SMYRNA MUNICIPAL PLANNING COMMISSION

March 6, 2025
5:00 p.m. meeting

AGENDA

MEETING MINUTES FEBRUARY 6, 2025

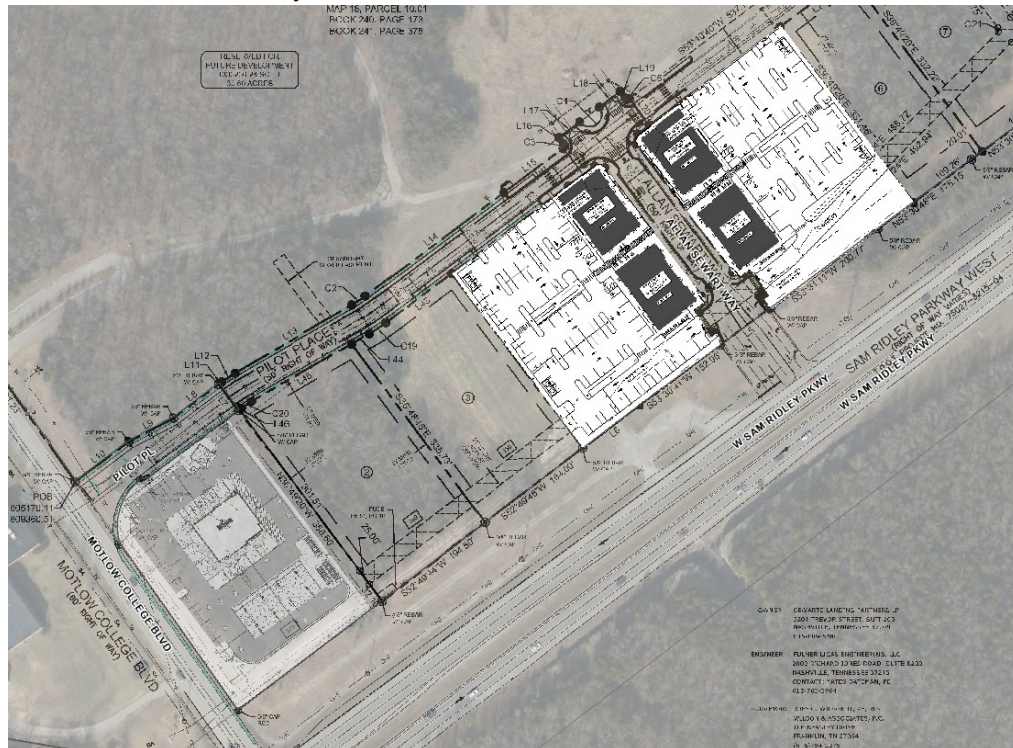
1. Please provide documentation from TDOT for landscaping within the right-of-way.
2. The minimum road width is 26' for any building over 30' tall.
3. The required minimum fire flow is 1,750 at 20 PSI. Buildings A & C will require a fire sprinkler system. No FDC's are allowed on the building and a fire hydrant must be within 100' of the FDC.

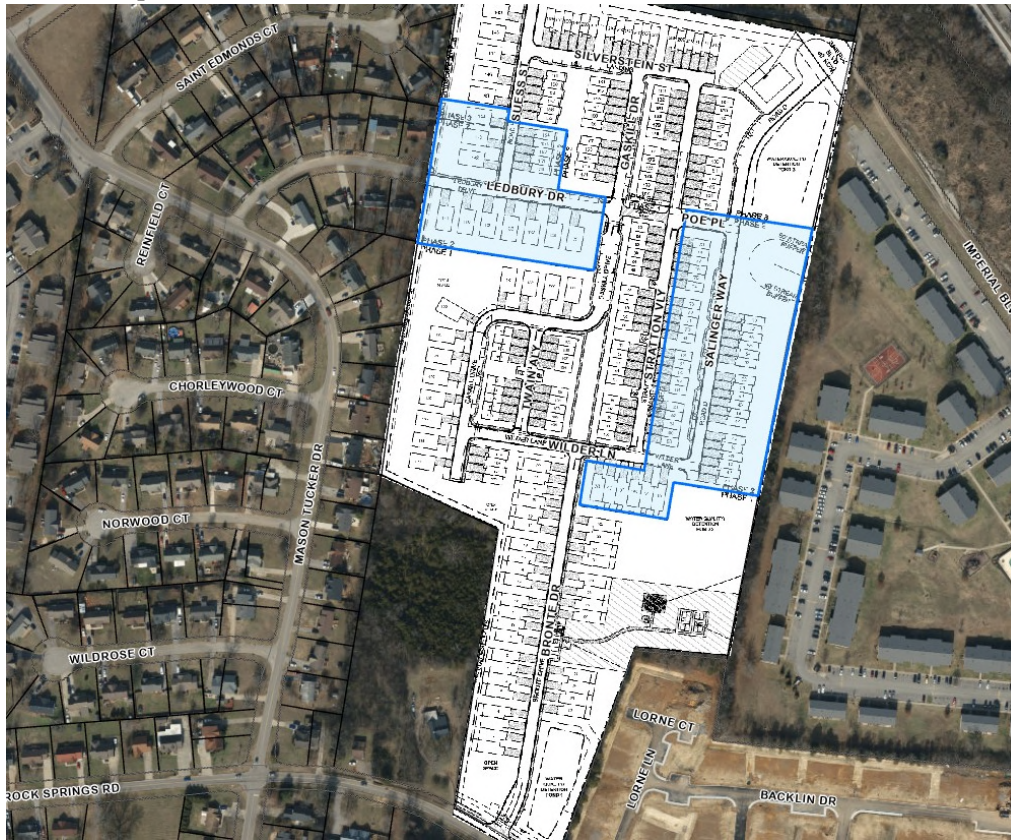
1. The Town is not able to provide fire flow protection for units 135-154 until the Imperial Boulevard improvements are made unless the units are sprinkled.

Planning Commission
Janet Ibrahim
3-6-2025

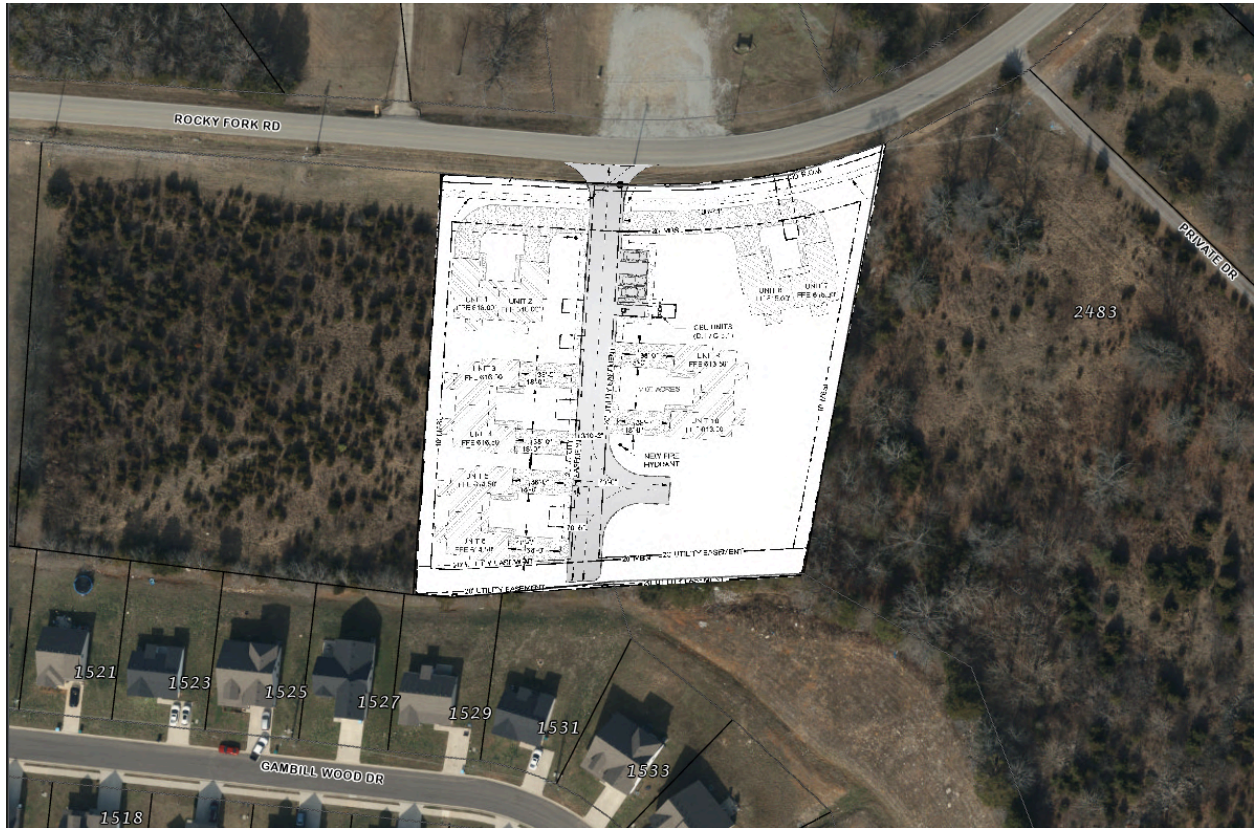
1. Submit and record the final plat prior to receiving building permits. Show right-of-way dedication and utility easements on the plat. Landscaping cannot be placed in the right-of-way.

2. Provide documentation where the developer has permission from the adjacent property owner to extend the sewer through the easement.
3. Submit architectural elevations to match what is shown on the approved PRD.

4. Landscape and storm structures cannot overlap. Out fall is shown running through the buffer.
5. Provide dimensions for the parking stalls.
6. Show all existing utilities around offsite sewer tie-in.

7. Submit construction plans including profile pages for proposed water and sewer mains.
8. Submit a plan showing proposed lighting and screening consistent with the requirements of the Enon Springs Overlay.

9. Show the existing tree canopy area including which portion of it will be preserved.
10. Show the existing water, sewer, and gas mains on Gambillwood Drive.

11. Show all proposed easements and offsite sewer easements.
12. Submit road name and E911 approval of that name.
13. Shift the storm pipe out of the landscape area.

Site Plan

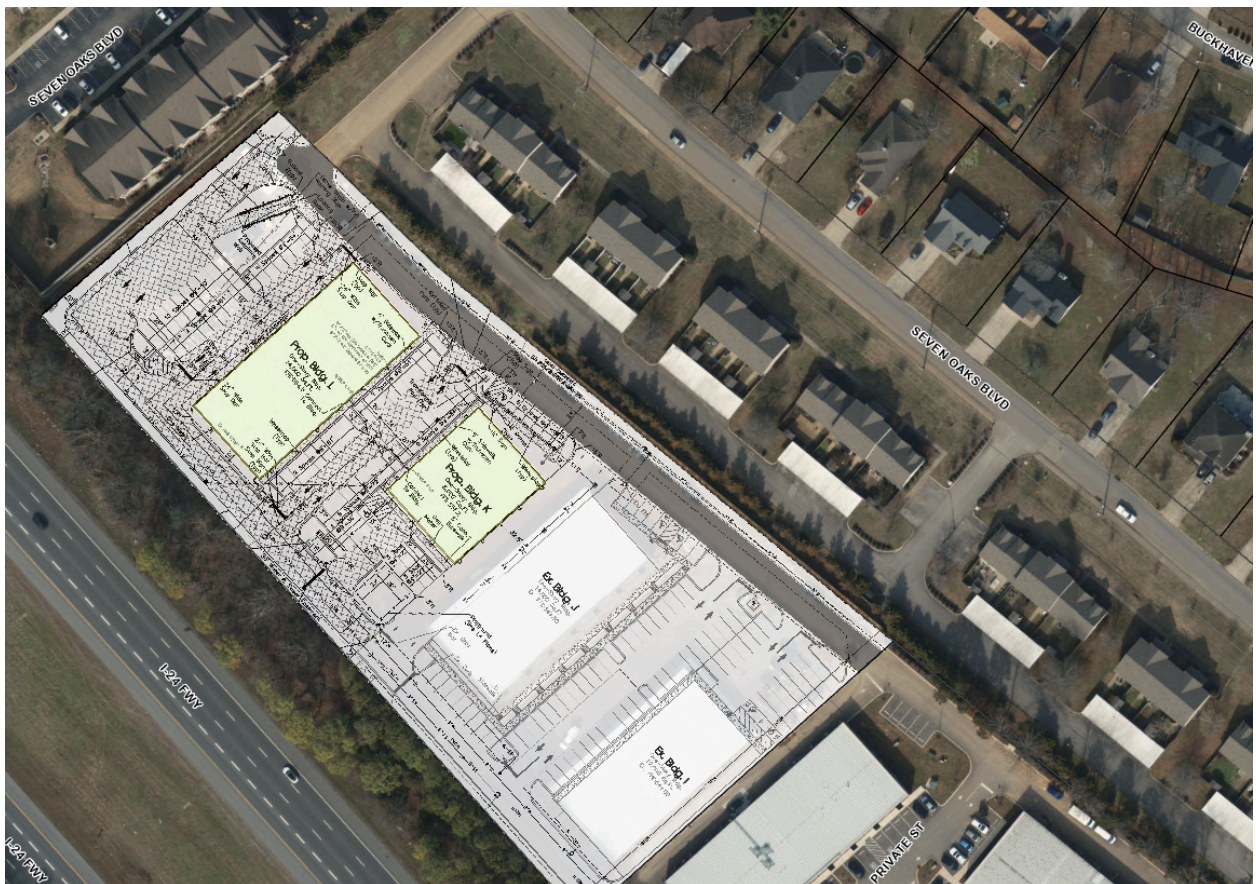
7. The required minimum fire flow for Building L is 2,500 GPM @ 20 PSI and for Building K is 2,000 GPM @ 20 PSI. Fire walls can be added to reduce the fire flow to 1,500 GPM @ 20 PSI.

1. Provide the maximum number of units and tenants for each building.
2. Any retaining wall over 4' requires a building permit.
3. A Type C landscape buffer is required along the northwestern property line abutting the apartments. The developer has requested a waiver from this requirement due to the fact that "The retaining wall for the apartment buildings located to the northwest of the site measures approximately 9 to 10 feet in height, with an additional 6-foot masonry screening wall on top, resulting in a total height of approximately 15 feet. Given this significant elevation difference, the buffer would have minimal to no impact on screening the site". The Planning Commission has the authority under the Zoning Ordinance to allow for existing fencing or vegetation to be used as all or part of a required buffer strip.

4. Label the three different numbers listed under "Impervious Area" on the cover sheet.
5. The number of parking spaces shown requires 4 ADA parking spaces, and only two are shown. Please add 2 ADA parking spaces near Building L.
